November 17, 2022
Project No. 19-113-SC

SUBJECT: ADDENDUM TO GEOTECHNICAL REPORT
Foundation Improvements
410 Kennedy Drive, Capitola, Santa Cruz County, California
APN 036-041-29

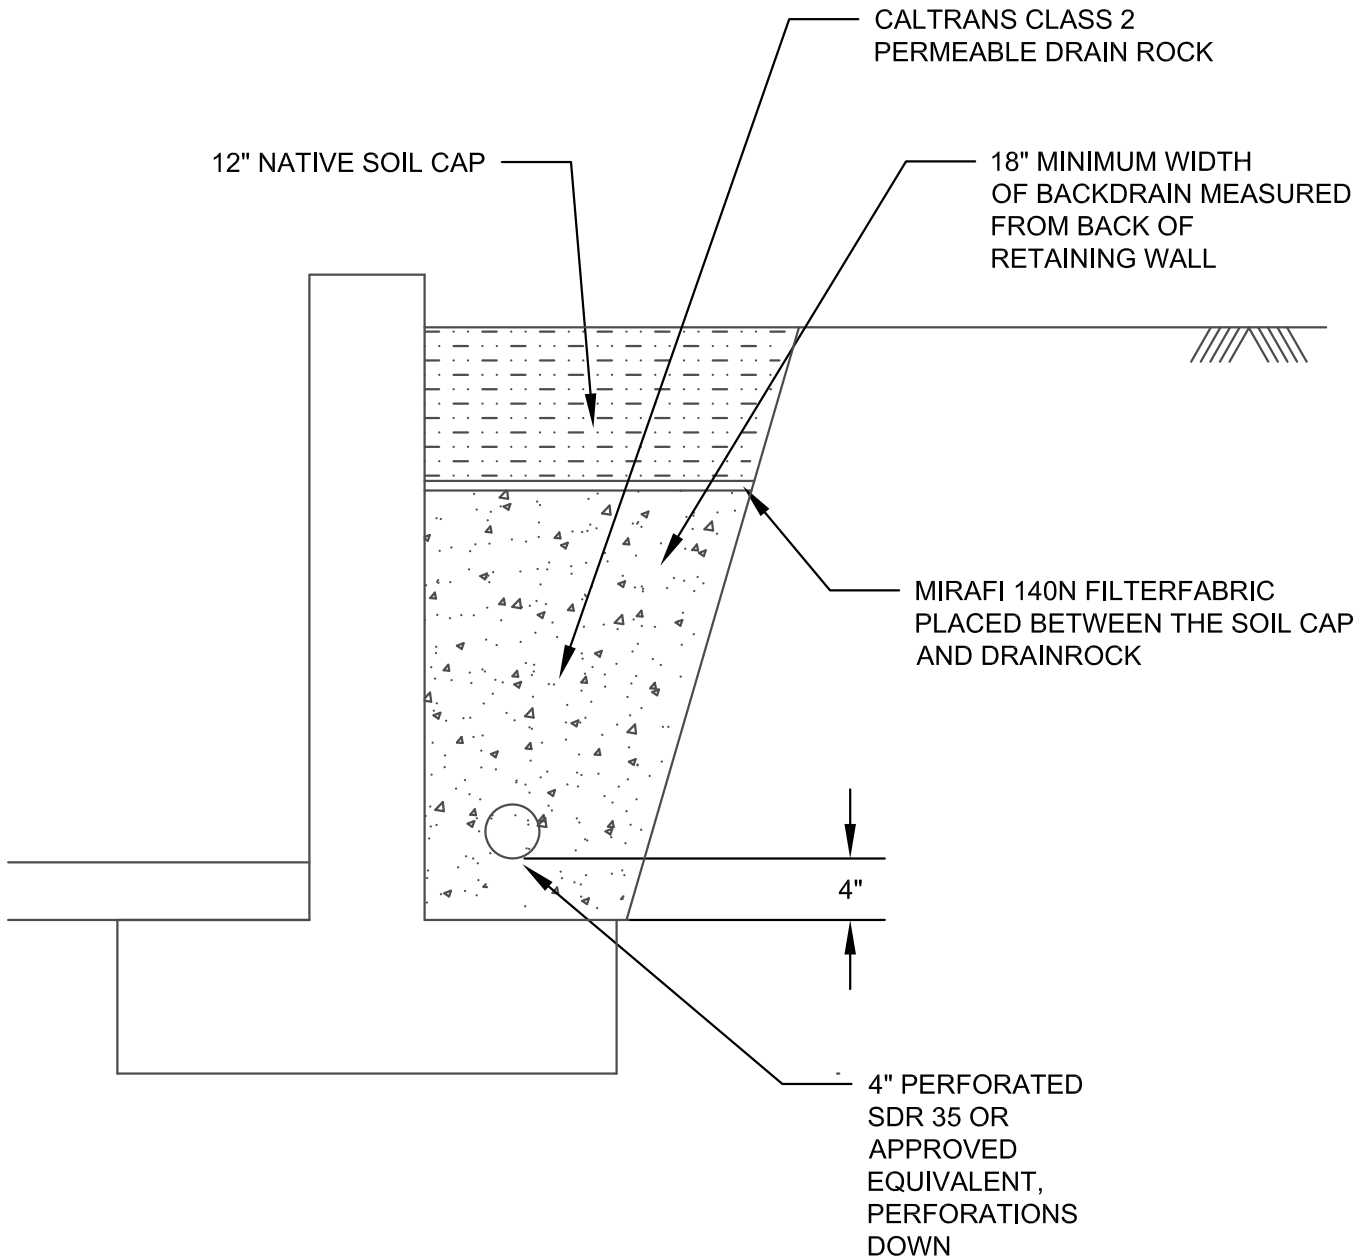
Backdrains should consist of 4 inch diameter SDR 35 PVC perforated pipe or equivalent, embedded in Caltrans Class 2 permeable drain rock. The drain should be a minimum of 18 inches in width and should extend to within 12 inches from the surface. The upper 12 inches should be capped with native soils. Mirafi 140N filter fabric should be placed between the native soil cap and the drain rock. The pipe should be 4± inches above the trench bottom; a gradient of 2± percent being provided to the pipe and trench bottom; discharging into suitably protected outlets. See Figure 1 for the standard detail for the backdrain.

Perforations in backdrains are recommended as follows: 1/2 inch diameter, in 2 rows at the ends of a 120 degree arc, at 5 inch centers in each row, staggered between rows, placed downward.

Backdrains should be observed by the Geotechnical Engineer after placement of bedding and pipe and prior to the placement of clean crushed gravel.

An unobstructed outlet should be provided at the lower end of each segment of backdrain. The outlet should consist of an unperforated pipe of the same diameter, connected to the perforated pipe and extended to a protected outlet at a lower elevation on a continuous gradient of at least 1 percent.
